FACILITY: San Onofre Nuclear Generating Station, Unit 1 (SONGS-1)

SUBJECT: SUMMARY OF MEETING TO DISCUSS APPENDIX R (FIRE PROTECTION) AT
SONGS-1

APPENDIX R COMPLIANCE
SAN ONOFRE UNIT 1
NOVEMBER 14, 1985

REACTIVITY CONTROL SCHEMATIC DIAGRAM

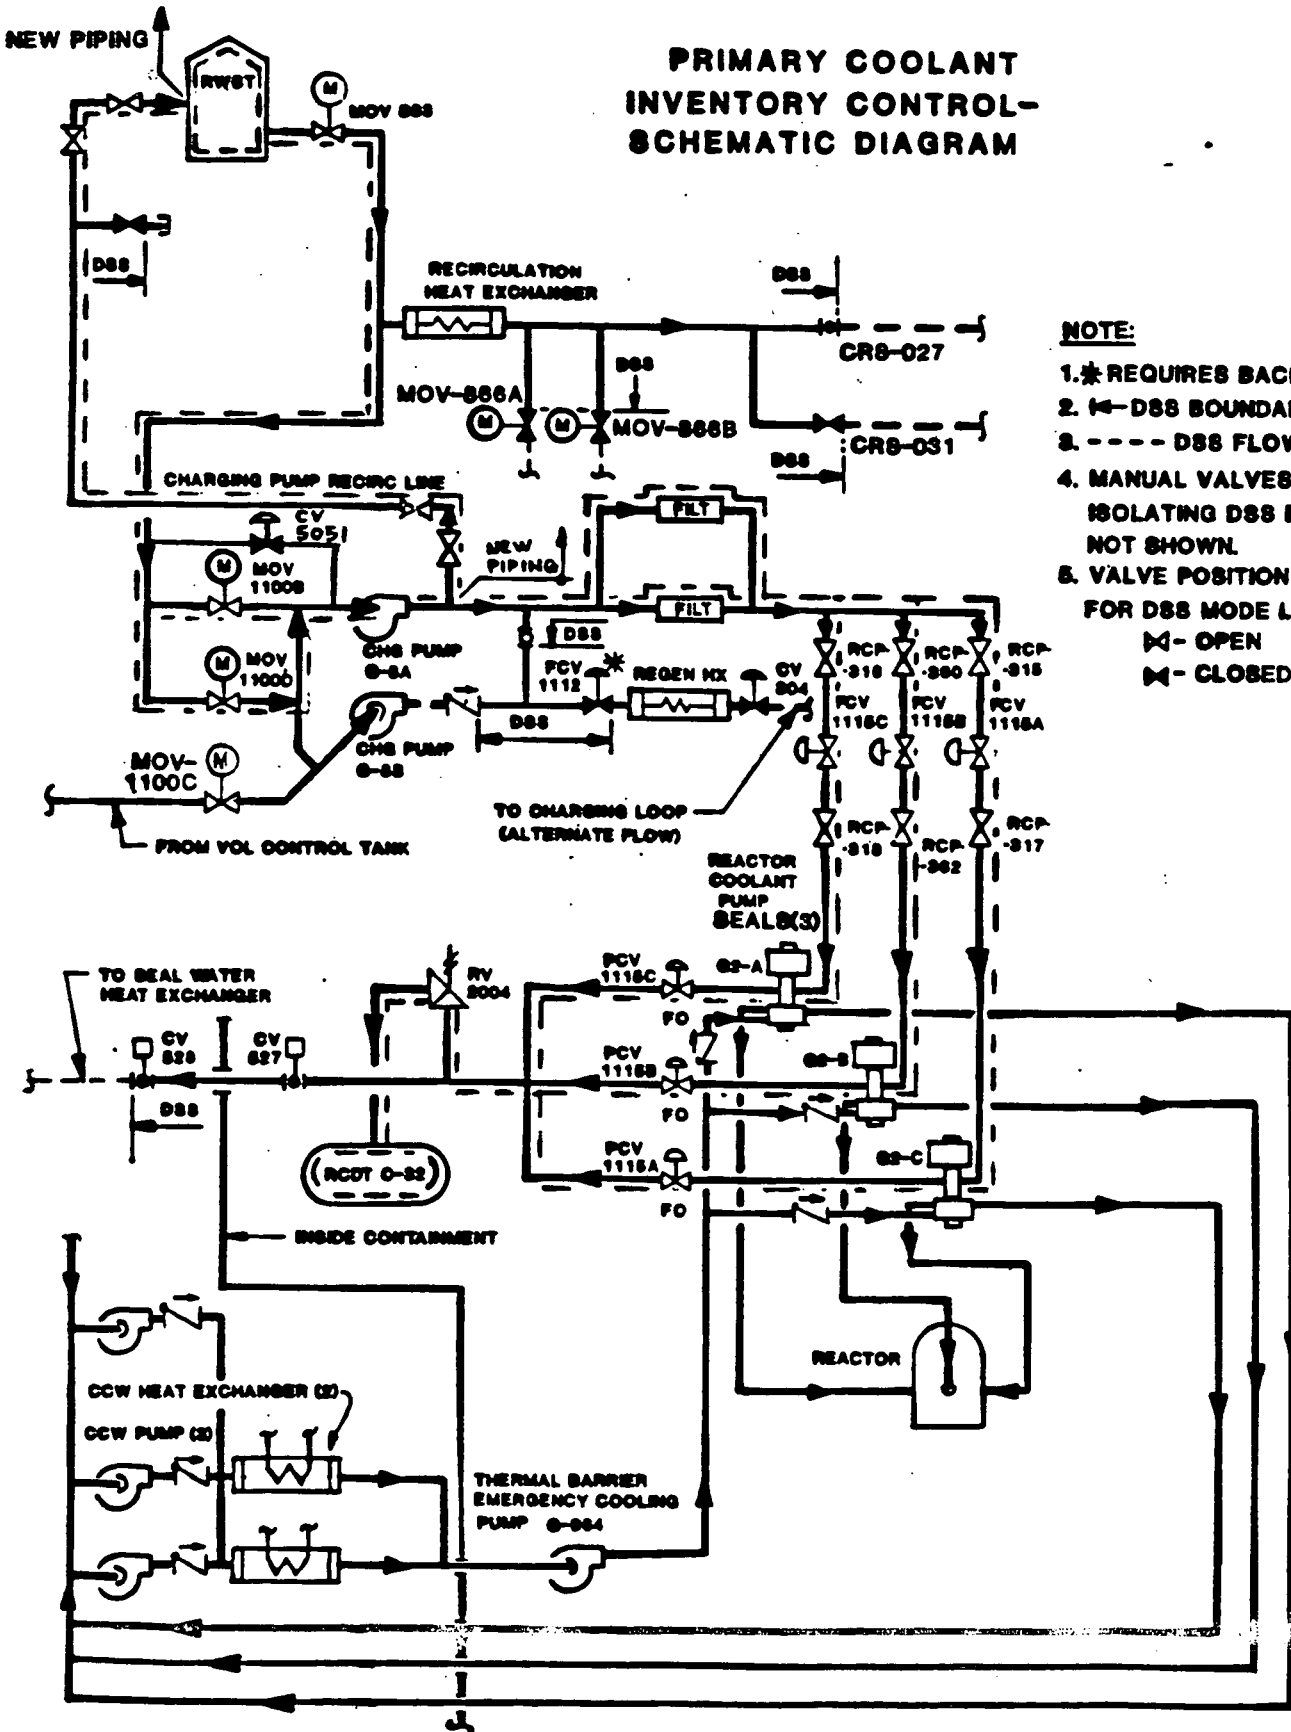
- ADD CHARGING PUMP RECIRCULATION LINE FOR
LOW FLOW INJECTION CONTROL 5/85
- DELETE CHARGING PUMP ROOM THERMAL BARRIER
AND HEAT SHIELD 10/85

PRIMARY COOLANT INVENTORY CONTROL- SCHEMATIC DIAGRAM

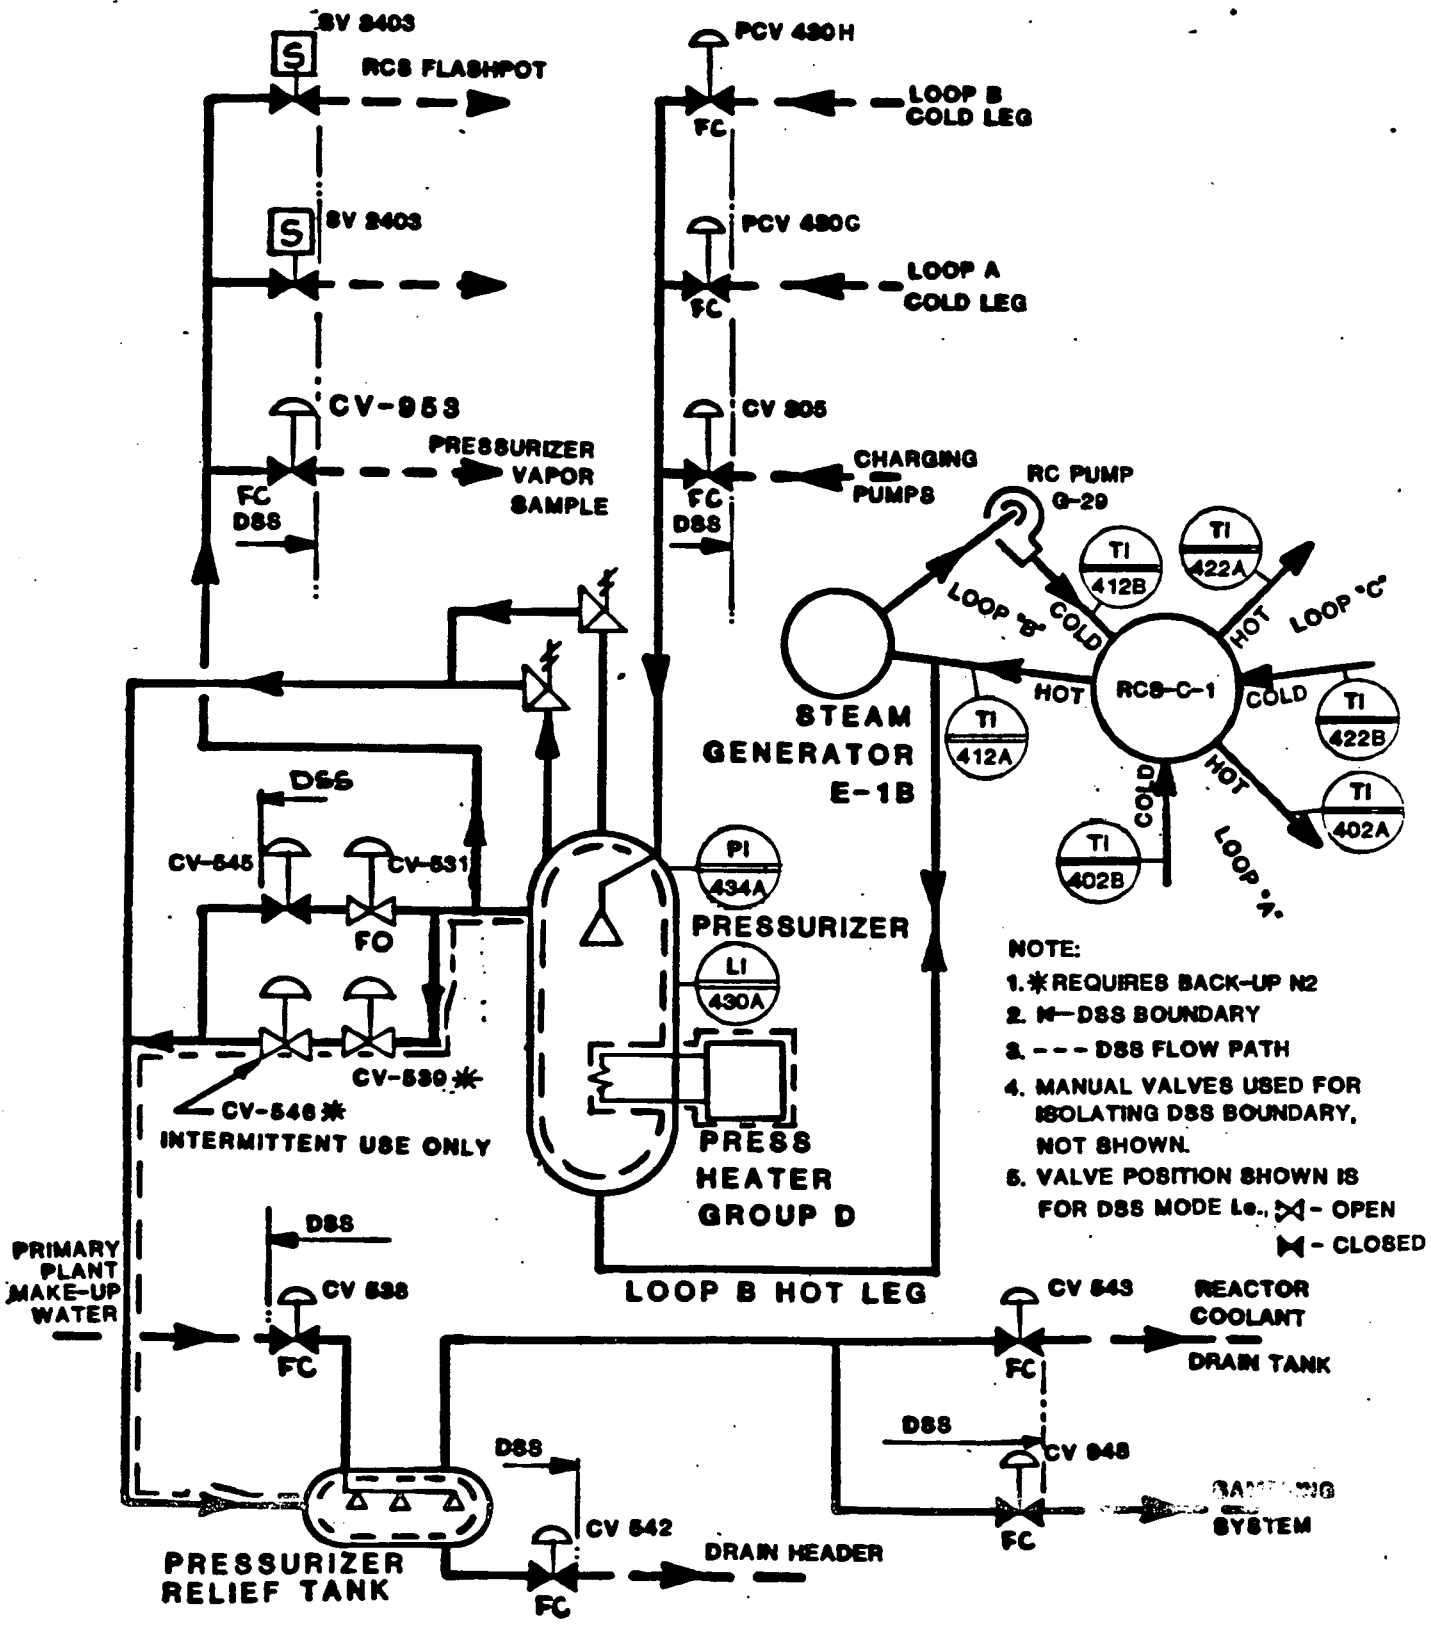
- THERMAL BARRIER COOLING PUMP NOT REQUIRED 10/85
- PROVIDE REMOTE CONTROL OF FCV-1112 FROM C-38 10/85
- PROVIDE N₂ BACKUP FOR FCV-1112 FROM C-38 10/85

PRIMARY COOLANT PRESSURE CONTROL SCHEMATIC DIAGRAM

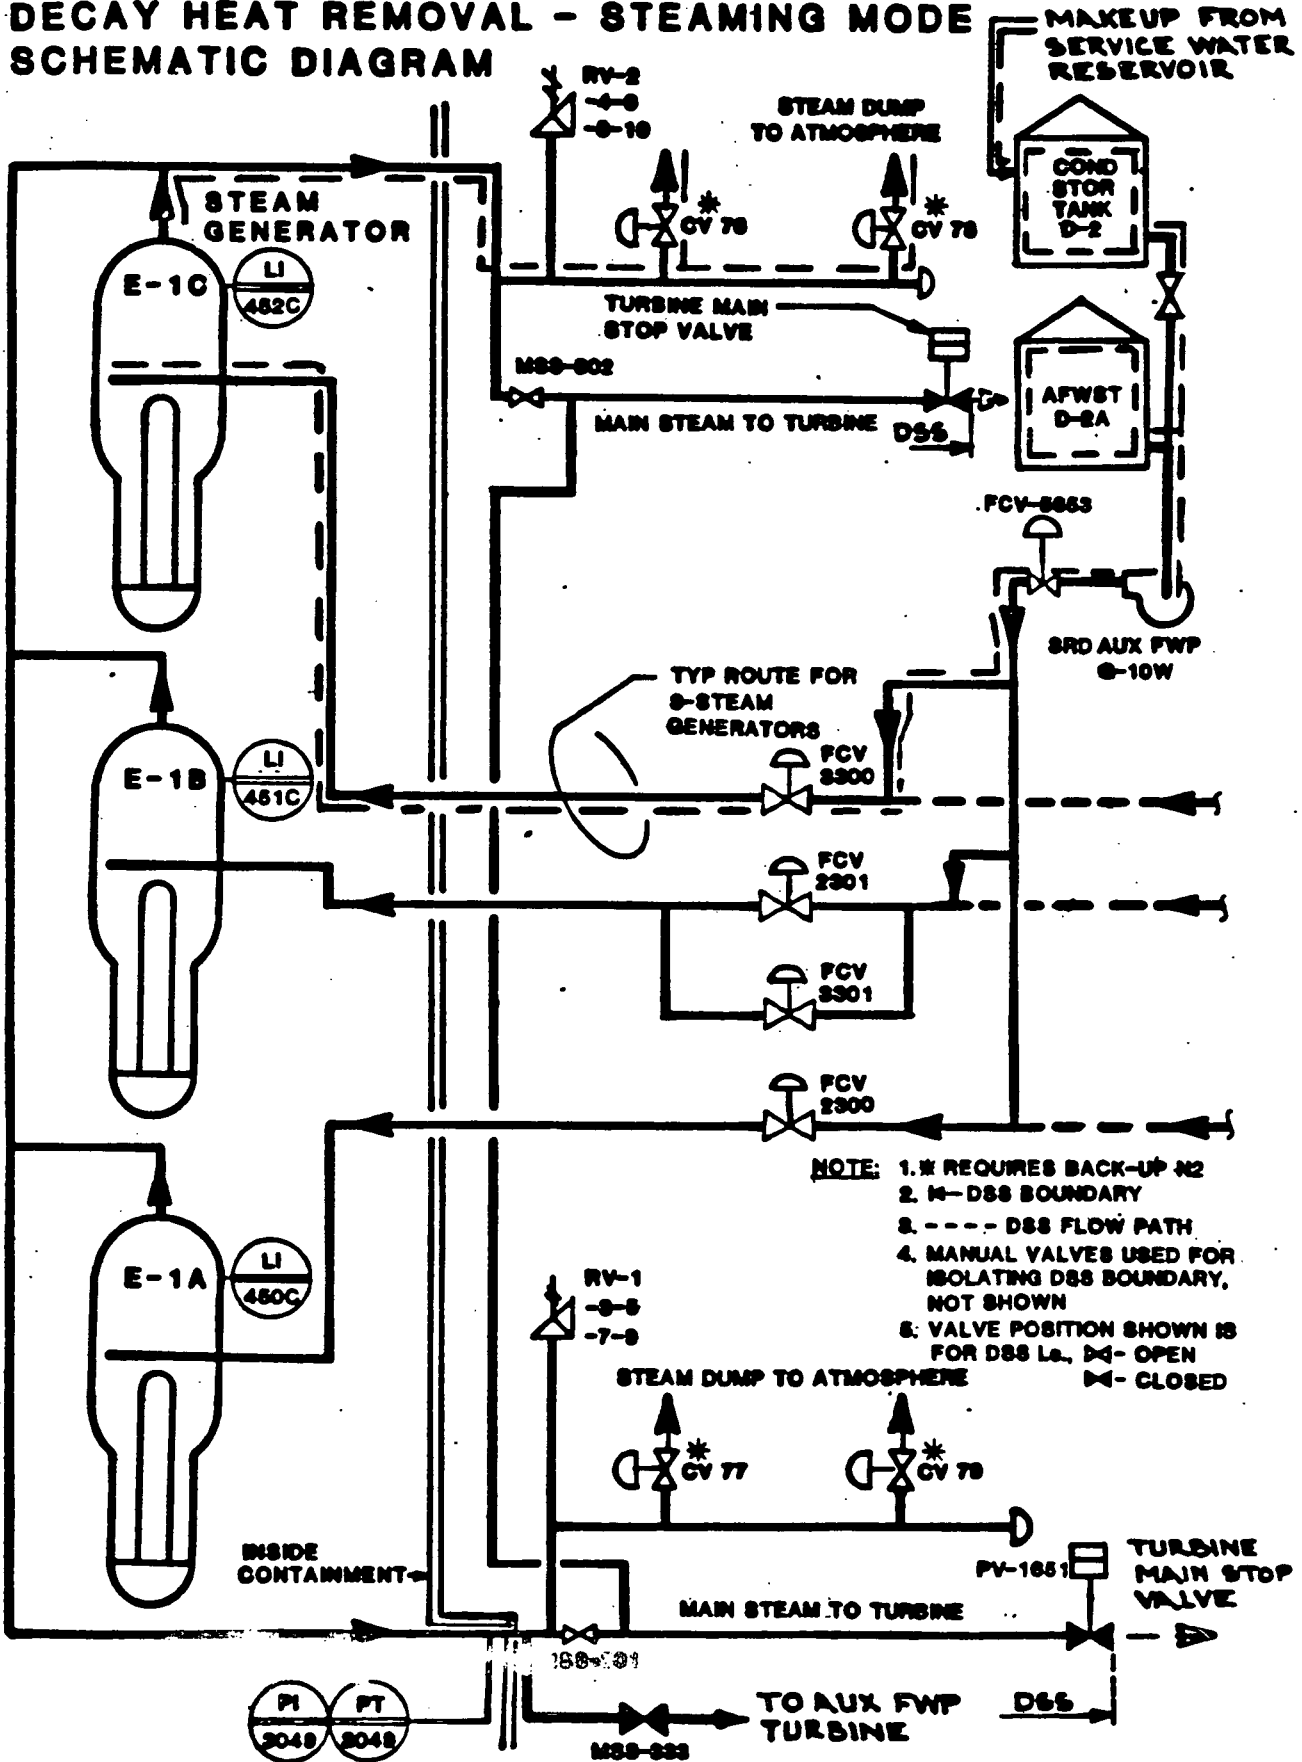
0 DELETED N₂ HARD BUBBLE IN THE PRESSURIZER
AND VALVE CV-953.

0 POWER HEATER BANK D FROM DSD

DECAY HEAT REMOVAL - STEAMING MODE SCHEMATIC DIAGRAM

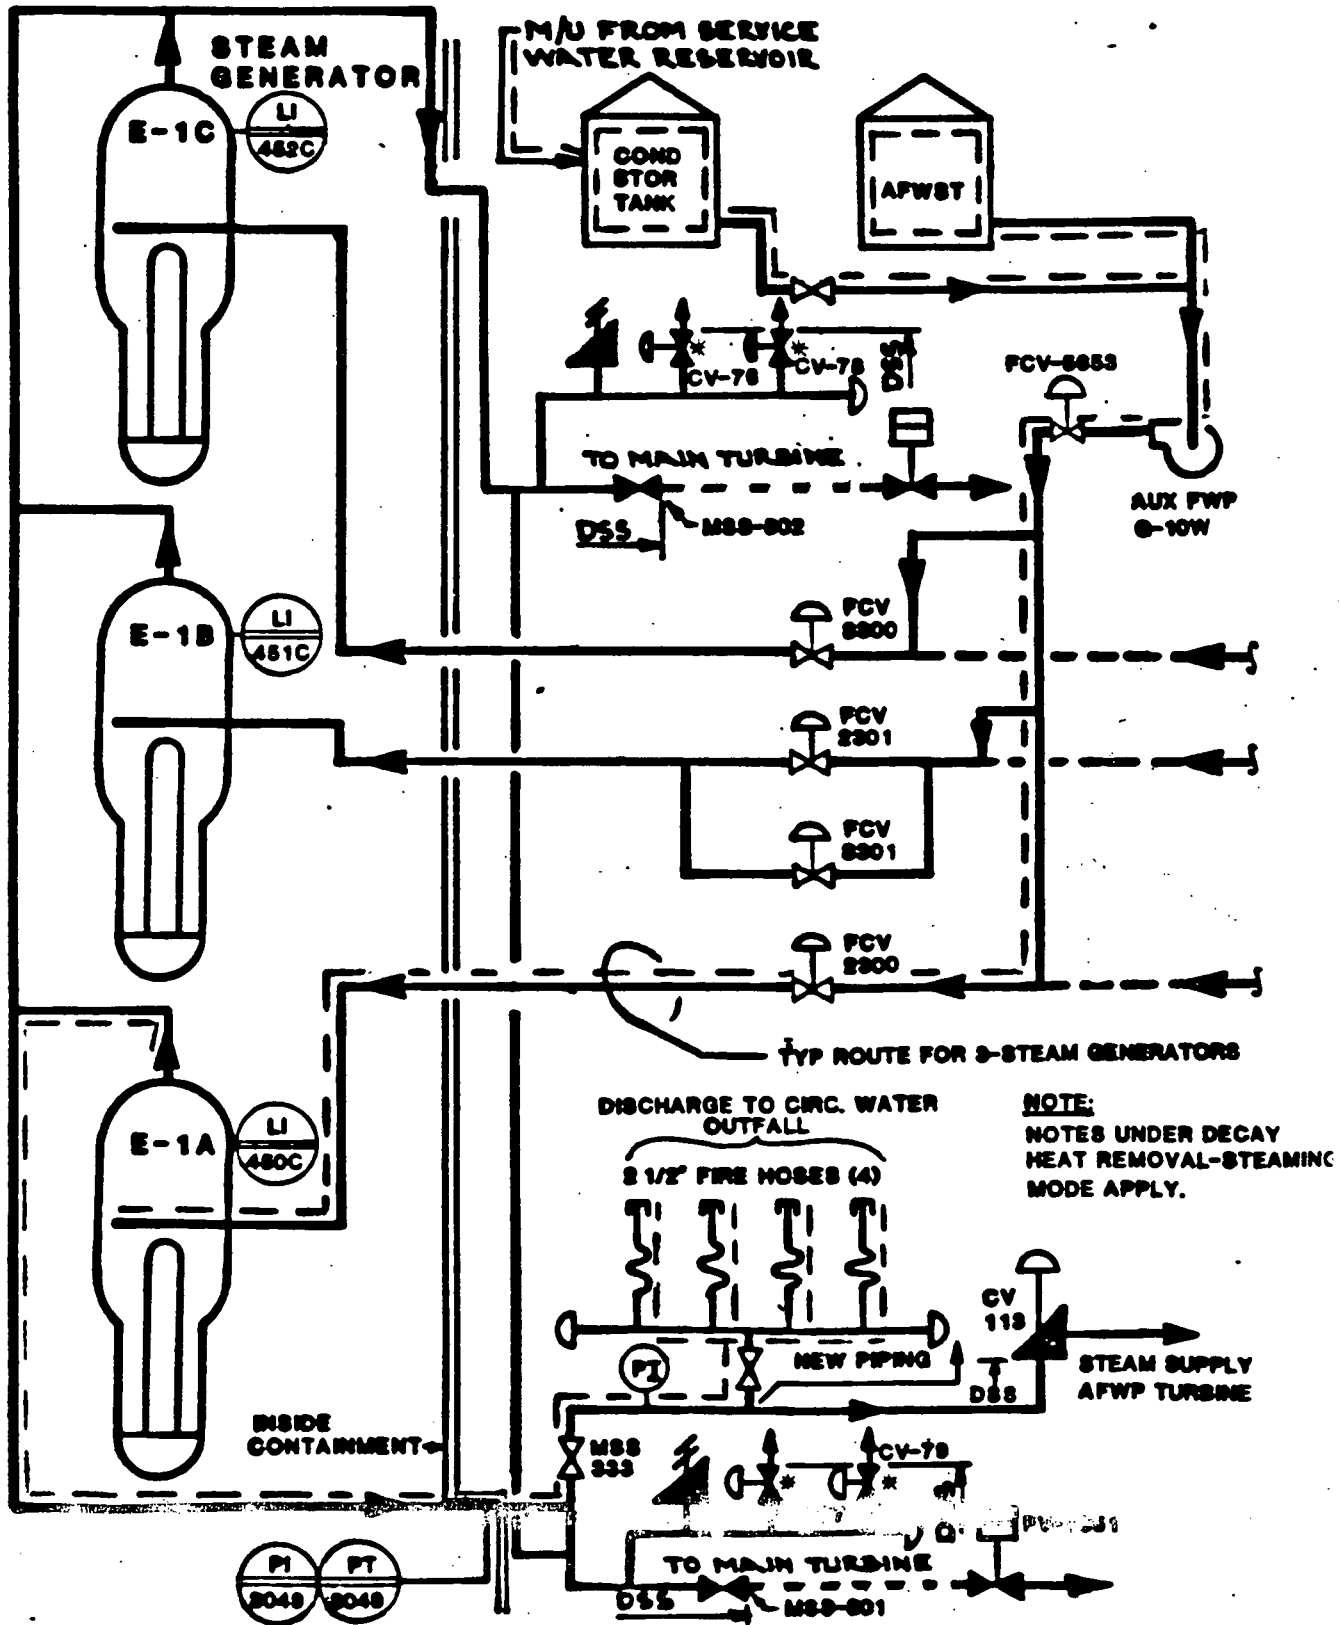
- ADD THIRD AUXILIARY FEEDWATER PUMP (G-10W),
PIPING, AND CONTROLS IN PLACE OF AUXILIARY
FEEDWATER PUMP G-10S NOT USED 10/85

- USE AUXILIARY FEEDWATER FLOW RATE OF
375 GPM INSTEAD OF 400 GPM. 5/85

- DELETE STEAM HEADER PRESSURE TRANSMITTER
FROM C-38 PANEL. PRESSURE GAGE IN SECONDARY
LETDOWN LINE TO BE USED —
